TO: ALL REGENCY COMMUNICATIONS PROFESSIONAL SALES & SERVICE CENTERS
ALL REGENCY COMMUNICATIONS PROFESSIONAL SALES REPRESENTATIVES

MODELS AFFECTED: MICRO-COM H40 Version I (P.C. Board 1700-7401-100)
MICRO-COM H40 Version II (P.C. Board 1700-7405-100)

PROBLEM: ALTERNATOR WHINE IN RECEIVER OUTPUT

FIG 2
SCHEMATIC AND PC BOARD AFTER MODIFICATION
MCH 40 VERSION I

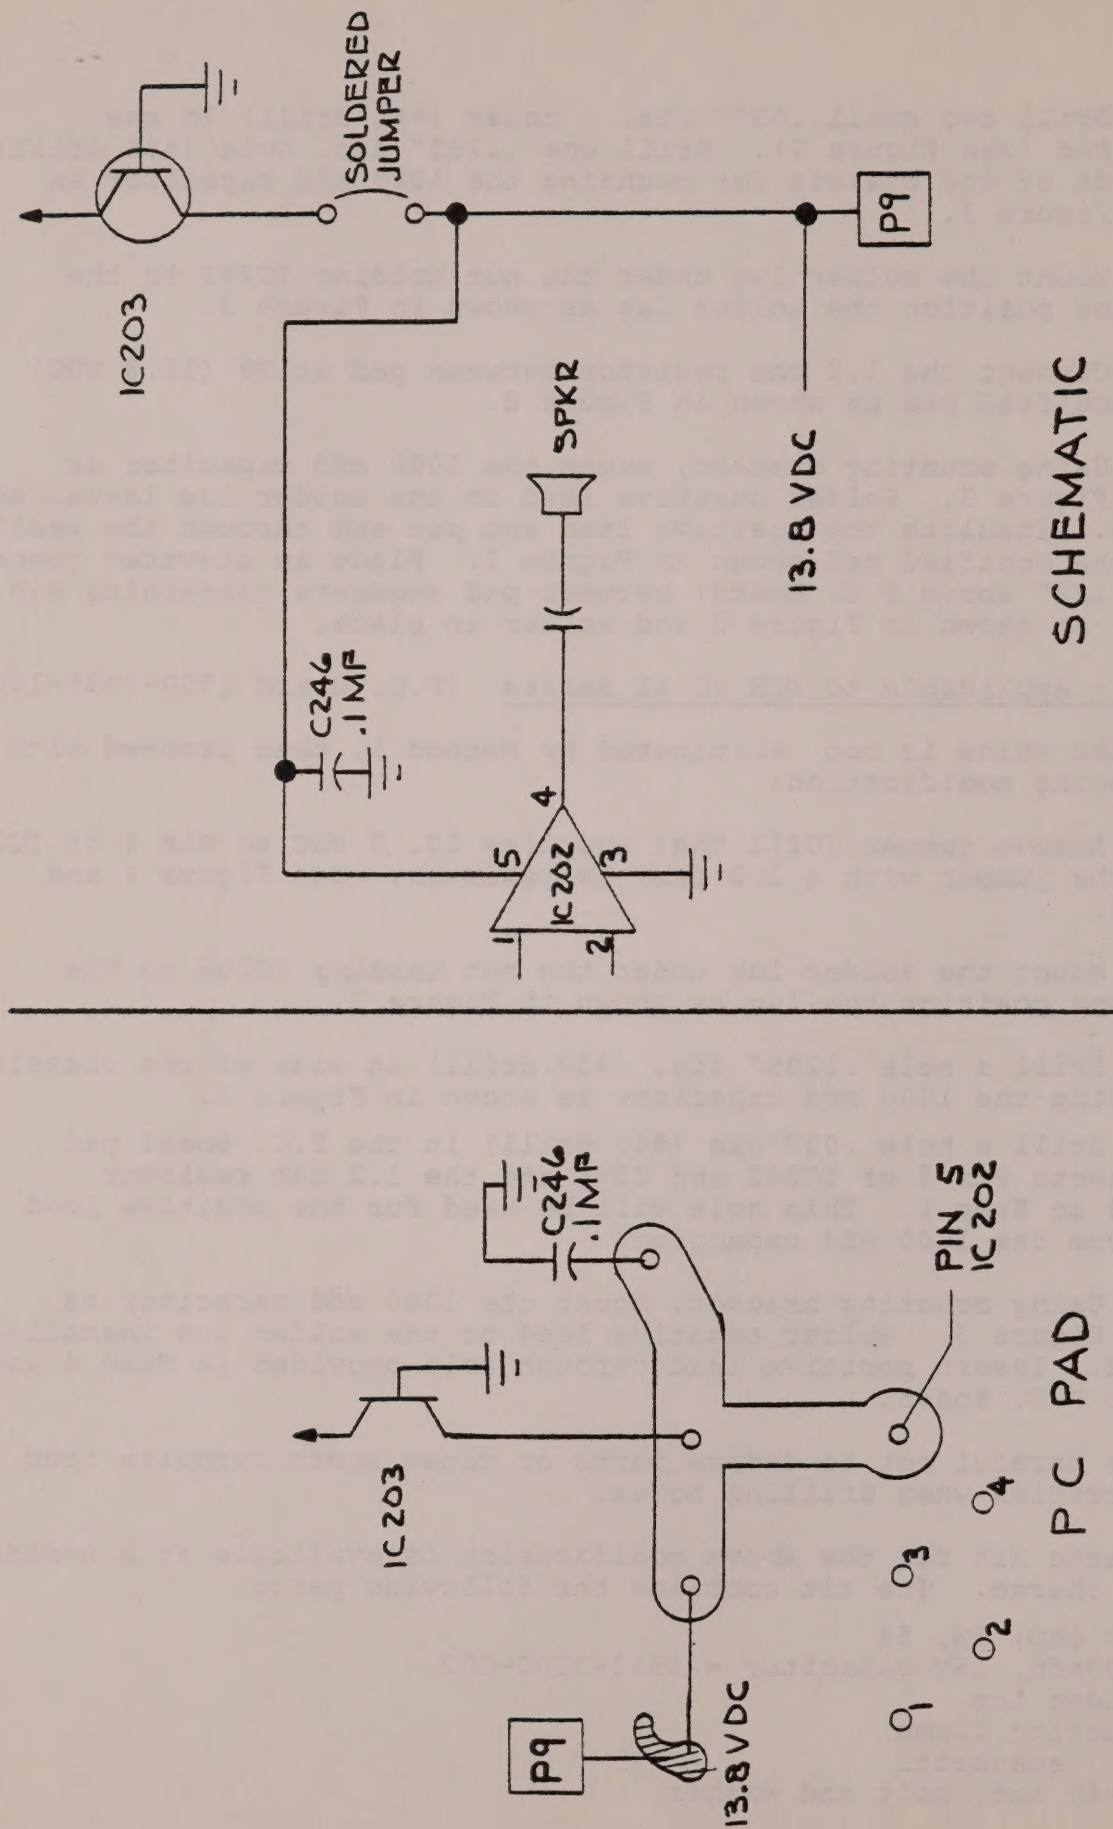
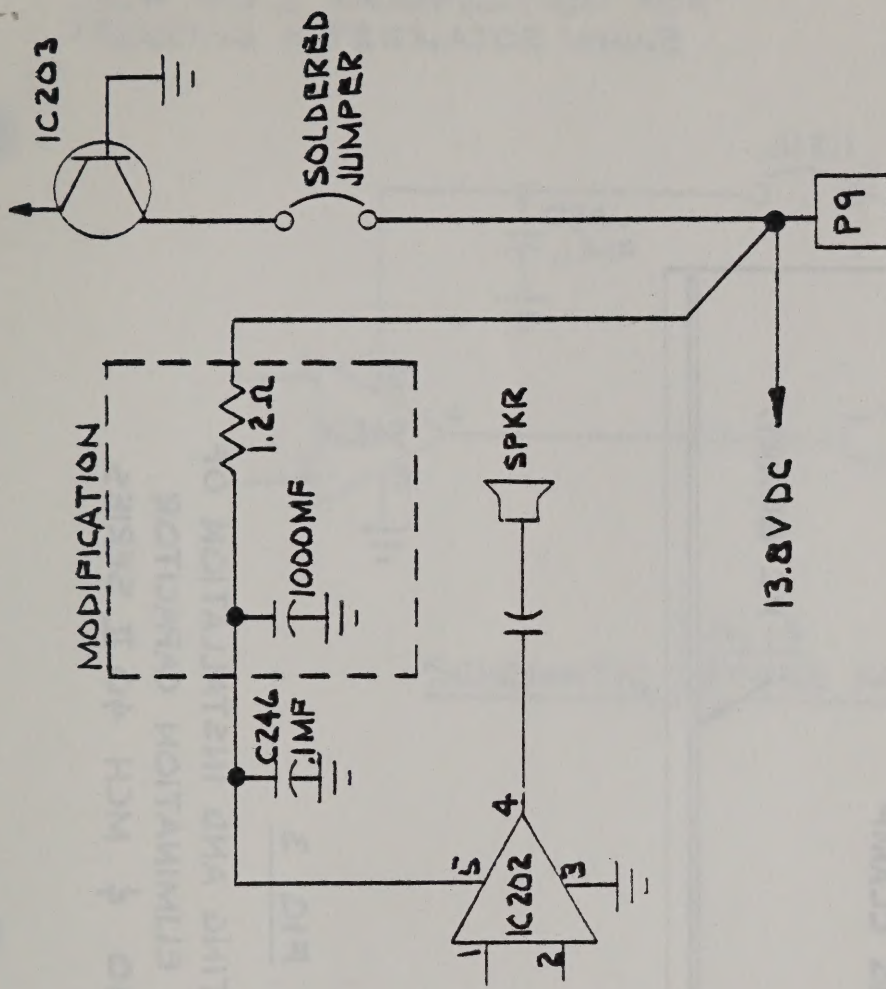
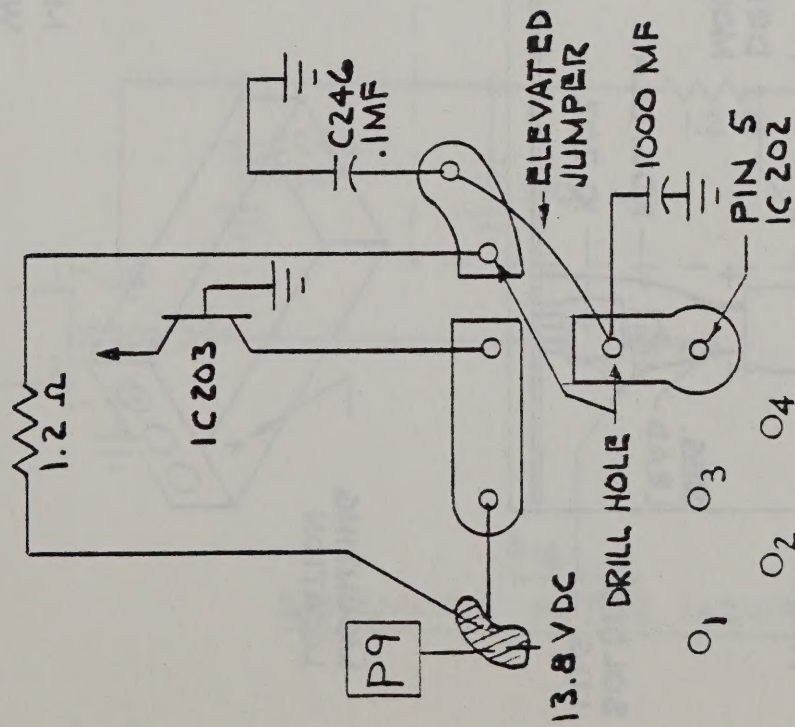
Step 1 - Refer to printed circuit board (Regency #704-011) and locate the pad and associated components shown in Figure 1. Remove the solder from the pad and use a sharp knife to modify the pad as shown in Figure 2.

Step 2 - Drill two small .037" dia. holes (#63 drill) in the modified pad (see Figure 2). Drill one .1285" dia. hole (#30 drill) in the side of the chassis for mounting the 1000 mfd capacitor as shown in Figure 3.

Step 4 - Connect the 1.2 ohm resistor between pad at P9 (13.8 VDC) and the modified pad as shown in Figure 2.

Step 5 - Using mounting bracket, mount the 1000 mfd capacitor as shown in Figure 3. Solder negative lead to the solder lug installed in Step 3. Insulate the positive lead and put end through the small hole in the modified pad shown in Figure 2. Place an elevated jumper (approx. 1/8" above P.C. Board) between pad segments containing Pin 5 and C246, as shown in Figure 2 and solder in place.

FIG 3

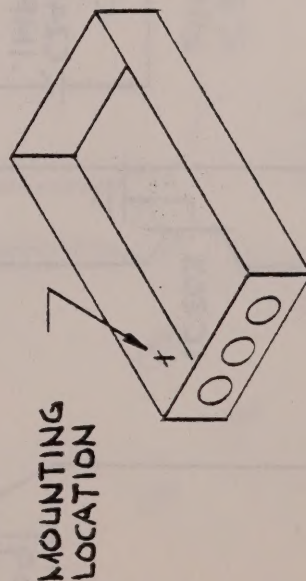
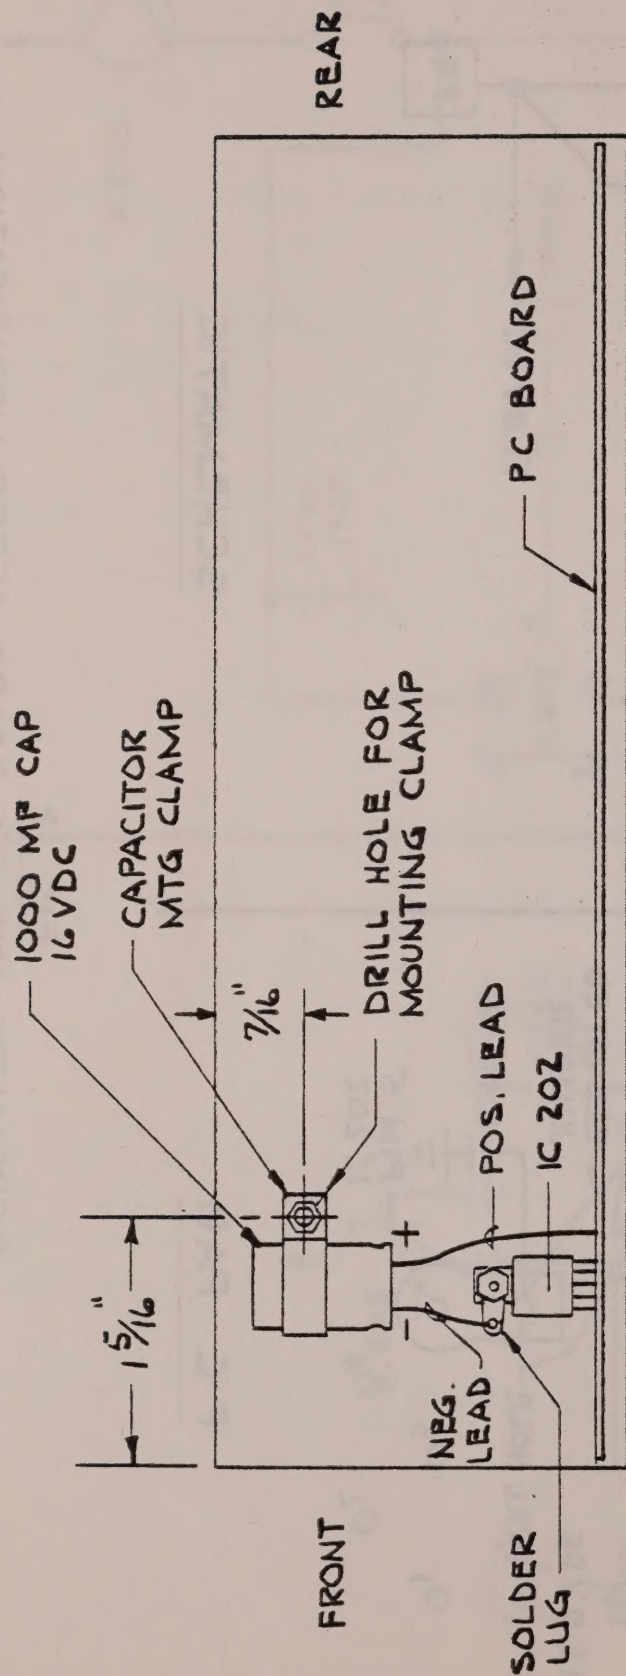
Step 3 - Mount the solder lug under the nut holding IC202 to the chassis and position the solder lug as shown in Figure 3.

Step 2 - Mount the solder lug under the nut holding IC202 to the chassis and position the lug as shown in Figure 3.

Step 3 - Drill a hole .1285" dia. (#30 drill) in side of the chassis for mounting the 1000 mfd capacitor as shown in Figure 3.

Step 5 - Using mounting bracket, mount the 1000 mfd capacitor as shown in Figure 3. Solder negative lead to the solder lug installed in Step 2. Insert positive lead through hole provided in Step 4 and solder to P.C. Board.

FIG. 4
SCHEMATIC BEFORE MODIFICATION

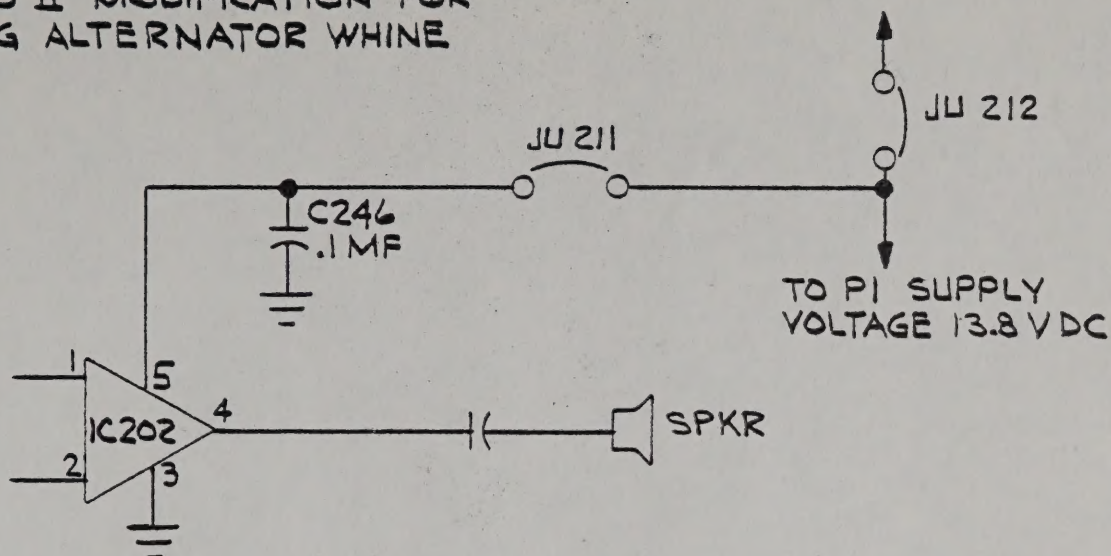
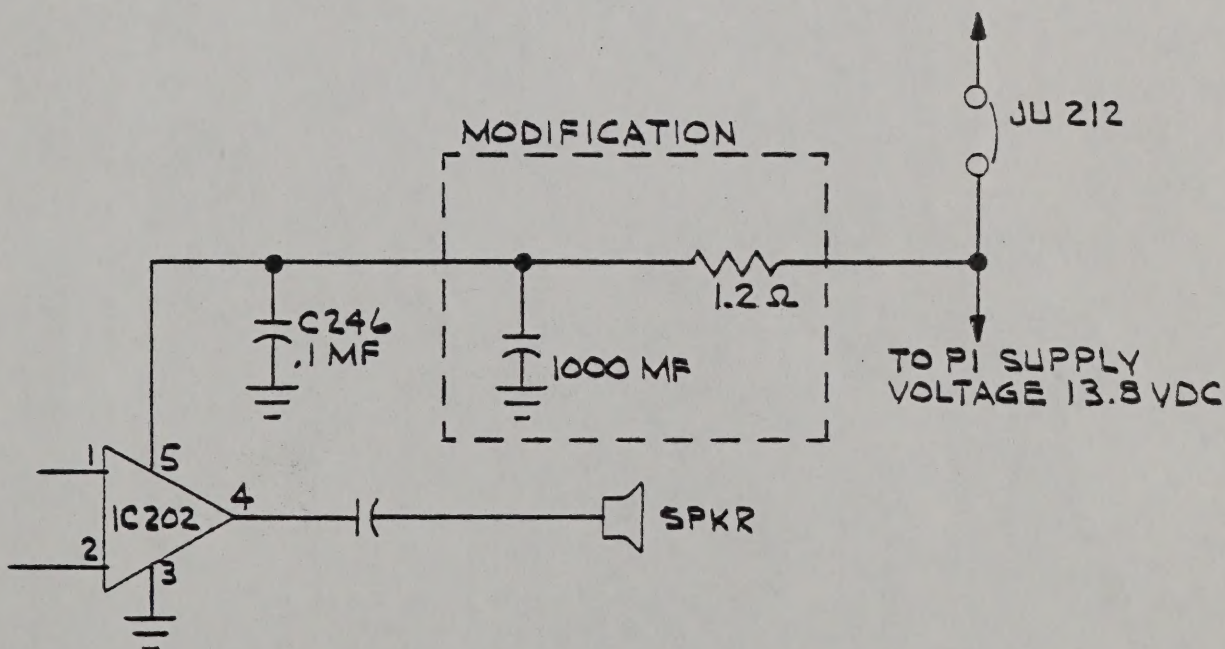
Step 1 - Remove jumper JU211 that supplies 13.8 VDC to Pin 5 of IC202. Replace the jumper with a 1.2 ohm, 1W resistor. See Figure 4 and Figure 5.

Step 4 - Drill a hole .037" dia (#63 drill) in the P.C. Board pad that connects Pin 5 of IC202 and C246 and the 1.2 ohm resistor installed in Step 1. This hole will be used for the positive lead coming from the 1000 mfd capacitor.
